TOWN OF MILFORD, NH  
OFFICE OF COMMUNITY DEVELOPMENT

**Date:** August 10, 2022  
**To:** Planning Board  
**From:** Lincoln Daley, Community Development Director  
**Subject:** SP2022-05 30 Wilton Road LLC for the property located at Tax Map 6, Lot 14, 30 Wilton Road. Public Hearing for a Conditional Use Permit/Major Site Plan Application to construct 3 story, 40 foot tall, 13,950 square foot (41,850 square foot gross floor area) self-storage facility and associated, parking, site and drainage improvements in the Integrated Commercial Industrial zoning District and West Elm Overlay. (*Continued from 7/21/22*)

PROJECT:  
**STORAGE SENSE - MILFORD WEST**

TITLE:  
**OVERVIEW PLAN**

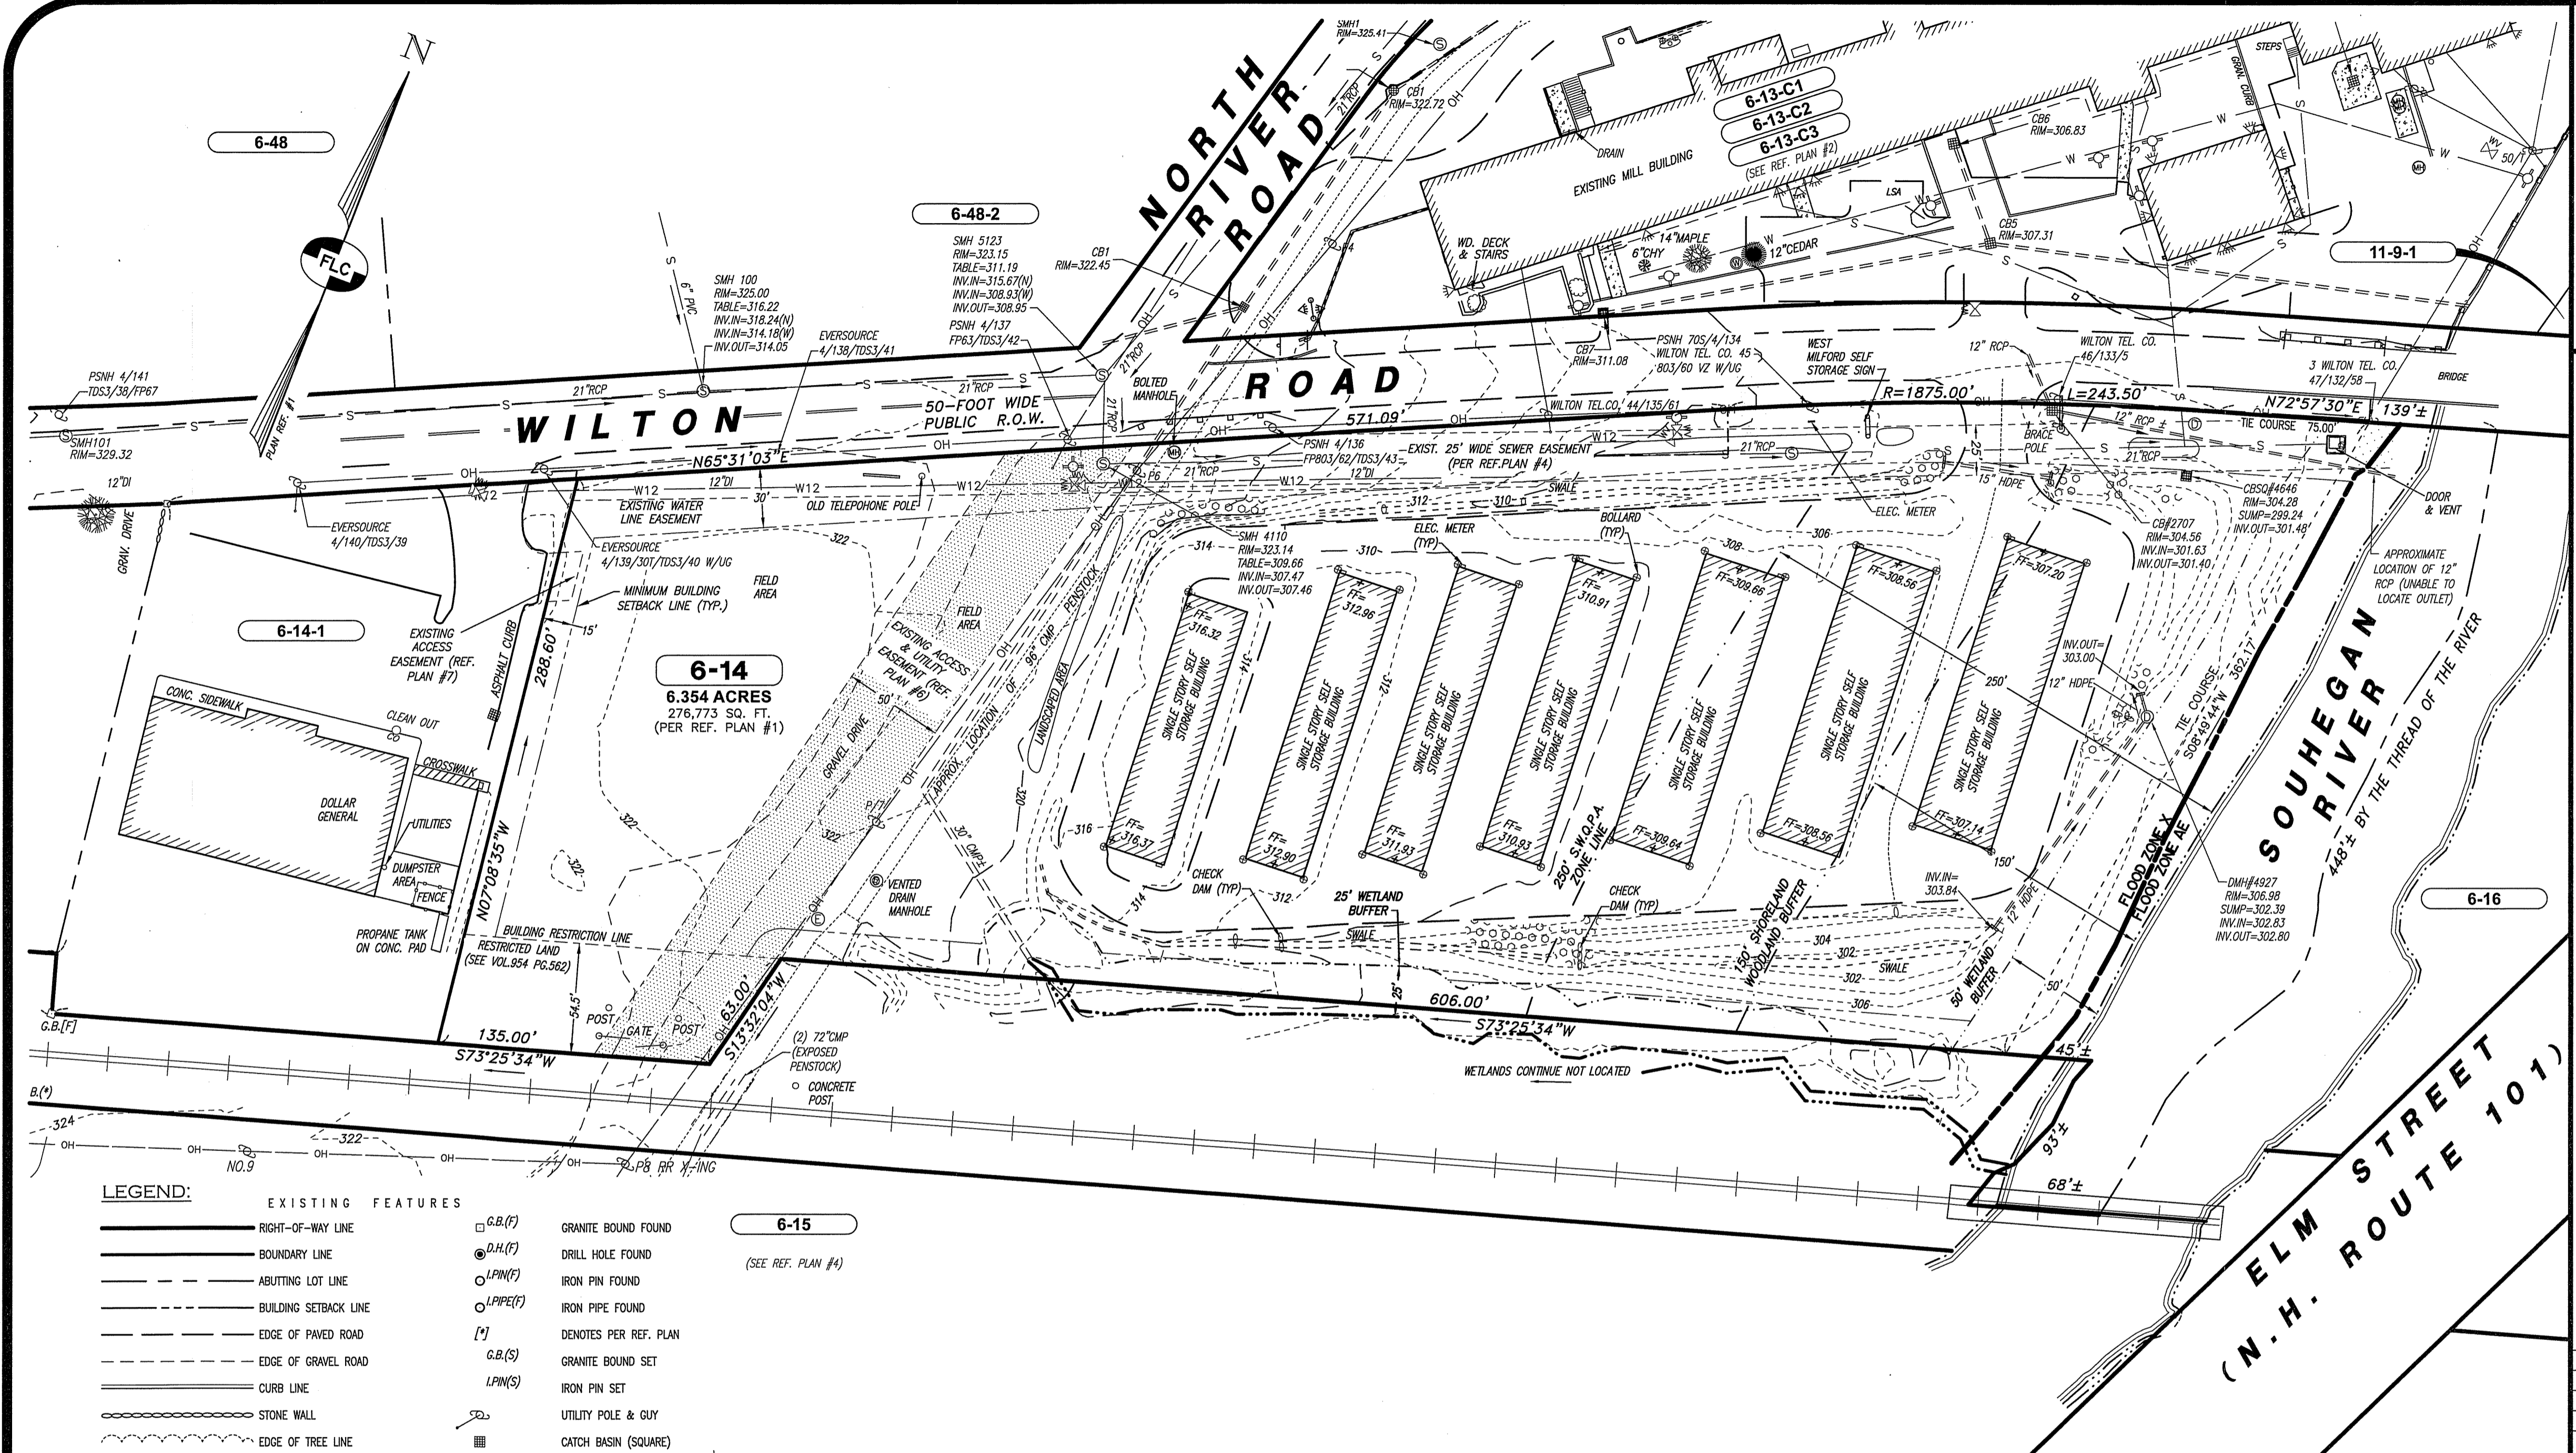
1. Sheet 1 and 4. Please confirm if the proposed internal roadway connecting the existing storage facility with the proposed building conflicts with ability to construct said road over the underground penstock. Will additional access/maintenance easement(s) be required? If yes, please revise the plans accordingly and submit draft easement.

4. Sheets 1, 4-7. Please revise the plans accordingly to include the location of the underground penstock.

1. Sheet 1 and 4. Please confirm if the proposed internal roadway connecting the existing storage facility with the proposed building conflicts with ability to construct said road over the underground penstock. Will additional access/maintenance easement(s) be required? If yes, please revise the plans accordingly and submit draft easement.

5. Sheets 1, 4-7. Please revise the plans accordingly to include the location of the underground penstock.

**The HydroCAD analysis has been revised in both pre- and post-construction conditions to match the existing conditions plan with regards to inverts and basin dimensions. Additionally, the plans proposed a change to the rim elevation of the outlet structure and the coring of a new orifice at the outlet control structure of Existing Infiltration Basin #1, see Sheets #1 & #5.**

TITLE:  
**SITE PLAN**

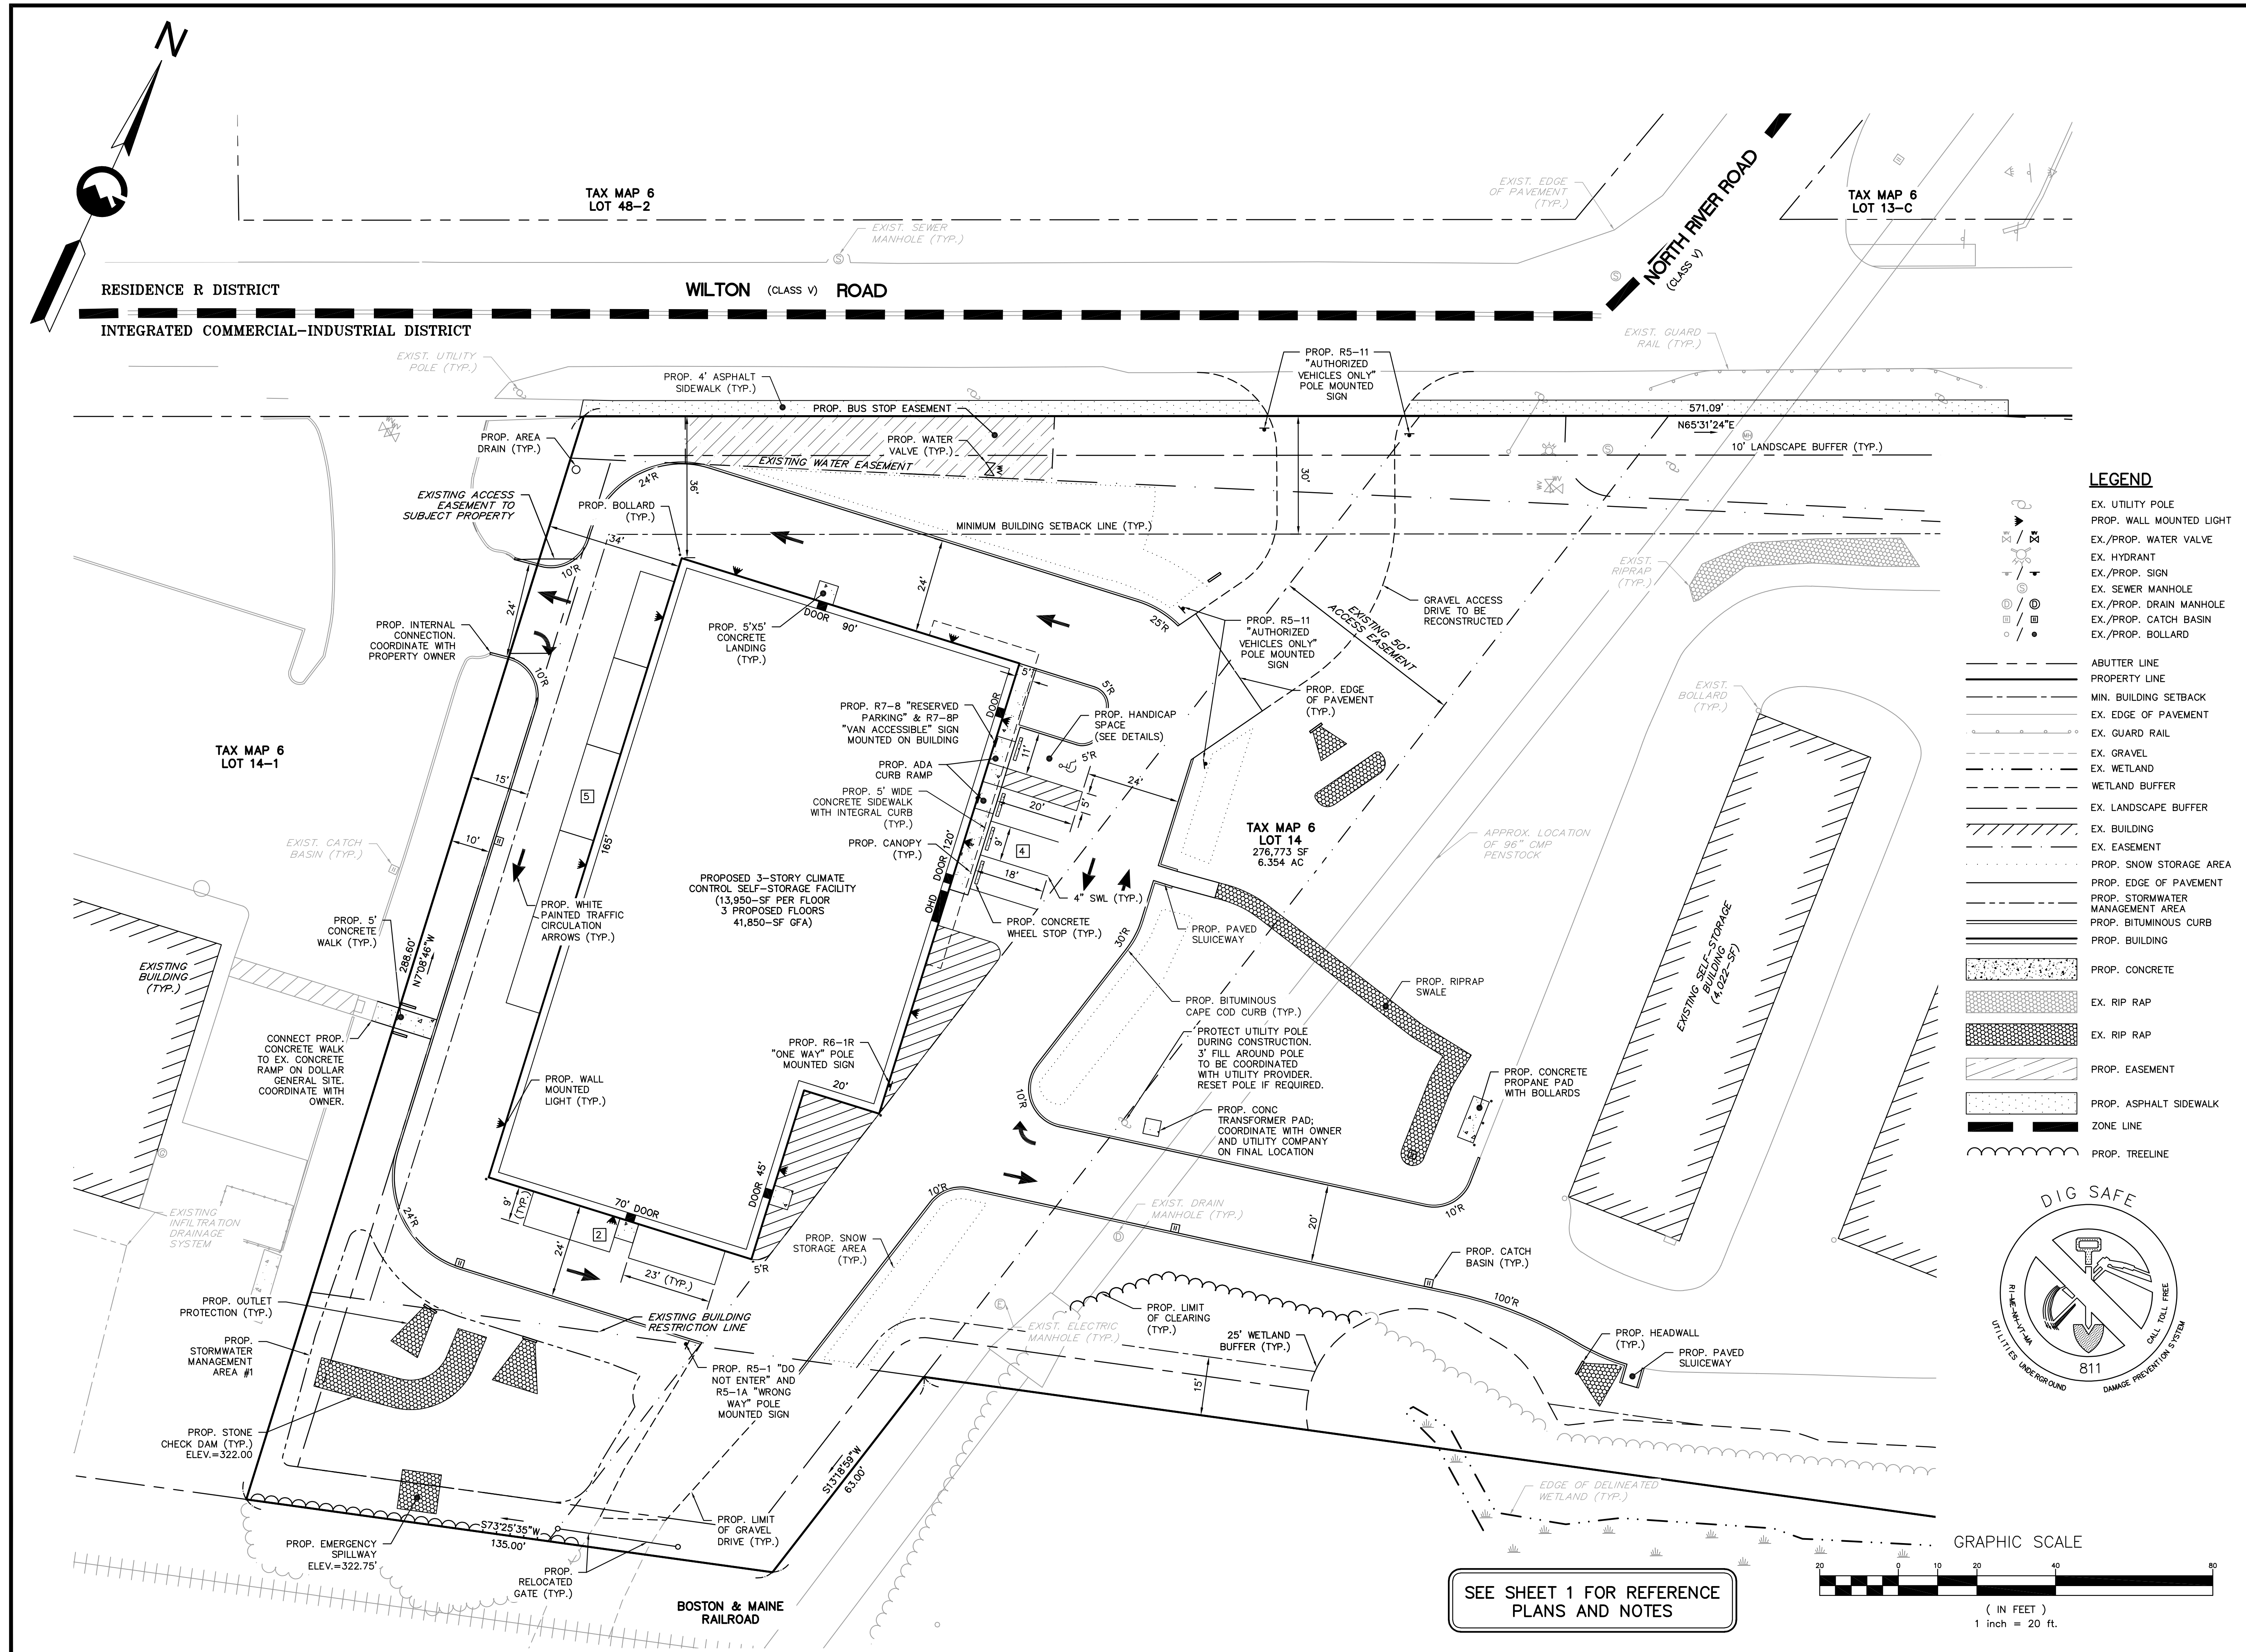
5. Sheet 4. Please explain the reason for locating the proposed propane pad and tank as shown on the plan in close proximity to the building. In addition, it is recommended that protective bollards be installed around concrete pad. *Comment Addressed – See 8/9/22 Response Letter*

6. Sheet 4. Please explain the reason for locating the proposed propane pad and tank as shown on the plan in close proximity to the building. In addition, it is recommended that protective bollards be installed around concrete pad.

**Snow Storage areas have been shown on Sheet 4, along with a note describing the procedure for snow removal and recommended a Certified Green Snow Professional.**
